SPRING HALL MOUNT - REVISED PLAN FOR FENCE - 15/12/24.

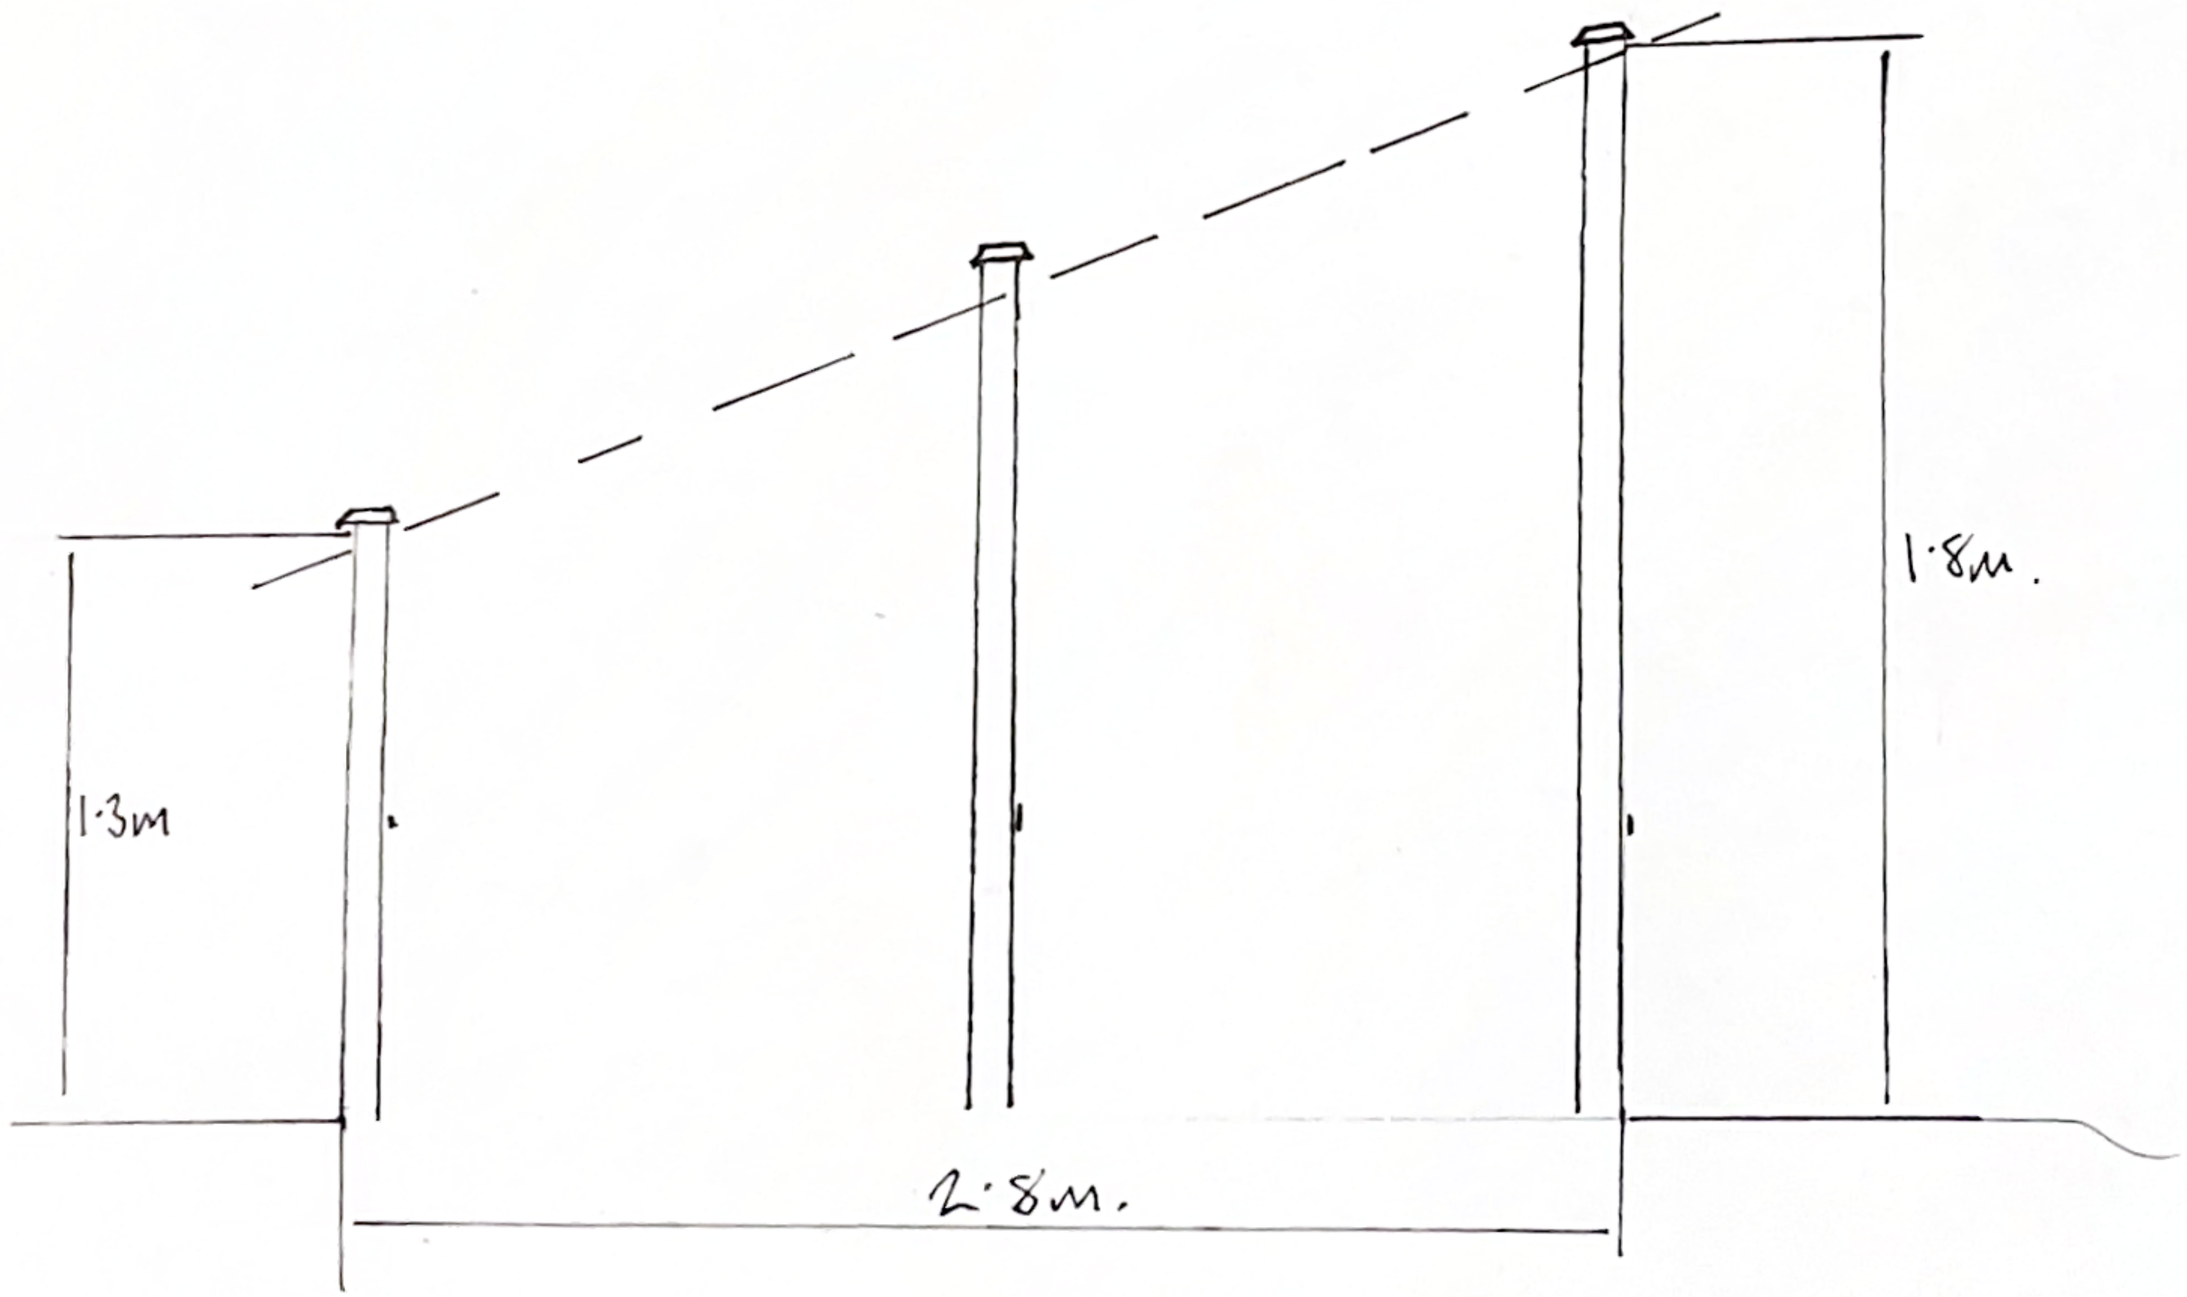
DESIGN: WHERE FENCE IS ADJACENT TO BINN LANE, HEIGHT TO BE REDUCED FROM 1·8m TO 1·3m OVER 2·8m. PLEASE REFER TO ADDITIONAL DESIGN STATEMENT AND PHOTOGRAPHS.
